Participant Feedback on LRMC Parameters

KEMA presented the draft update report on LRMC Technical Parameters at a meeting with representatives of the industry on 3rd July 2009. Subsequent to this meeting written comments/responses have been provided by various participants. This report provides KEMA response to these.

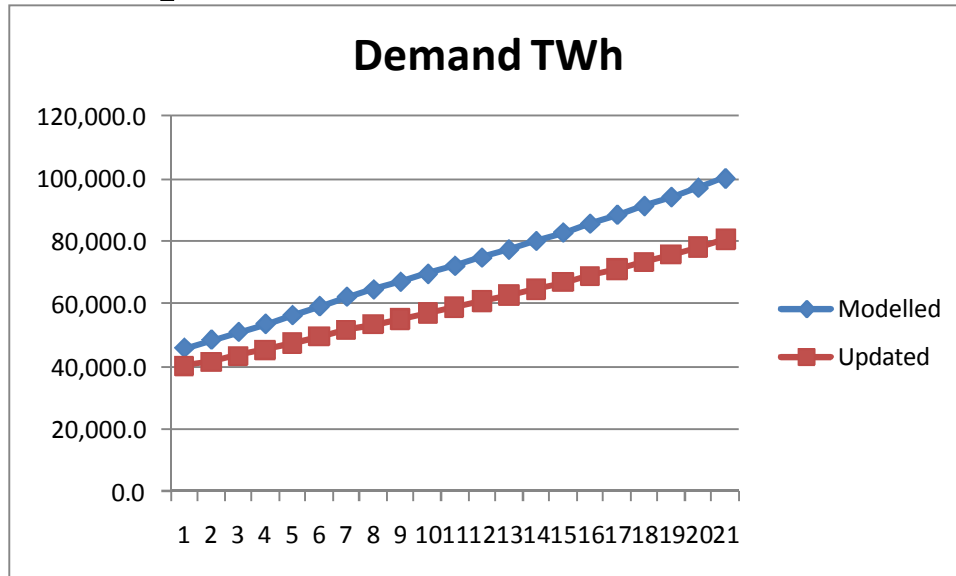
Demand forecasts have changed since the last reset and should be used to re-model the plant heat rate. Expectation is that the plant will be scheduled at lower outputs and therefore have a worse heat rate equating to lower efficiency and therefore higher running cost. Additionally assumptions regarding planting should be updated to reflect generation companies' latest plans.

EMA have updated demand forecasts to reflect the economic downturn. The revised forecasts are shown graphically below:

From a review of these figures and analysis of the model outputs KEMA conclude that, whilst the lower current demand forecast would impact on new planting to maintain the reserve margin post planting of the Proxy, there would be no impact on the Proxy load factor and corresponding heat rate is in any event being the lowest cost generator at the time it enters the market.

NOTE: KEMA do not model market behavior but rather fundamental cost based dispatch. Since the proxy plant is at the top (i.e. baseload end) of the merit order stack its only competition for dispatch comes in off-peak periods. Consequently re-modeling will not produce a material difference in the heat rate to be used.
